Solicitation #36C77623B0075 Construct Mental Health Outpatient Bldg. 52 - Fargo
Technical Questions and VA Response Tracking Sheet

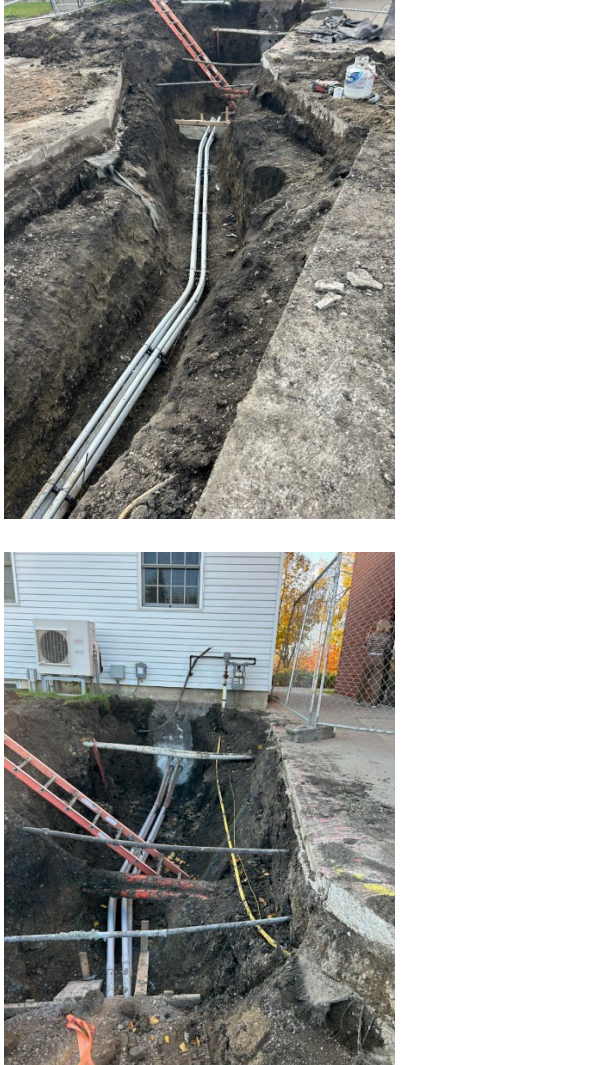
22.	11-3-23	11-17-23	Underground electrical duct banks have been installed since these drawings were issued. Will additional drawings or information be provided for newly installed underground electrical work?	<p>No. Verify new electrical work with the VA.</p> <p>See image below for approximate locations of new electrical duct bank. The blue hatched line is the area not encased in concrete and just buried conduit lines. The angled electrical duct bank ends at the existing concrete curb north of Bldg 30W. Contractor to verify exact locations.</p>
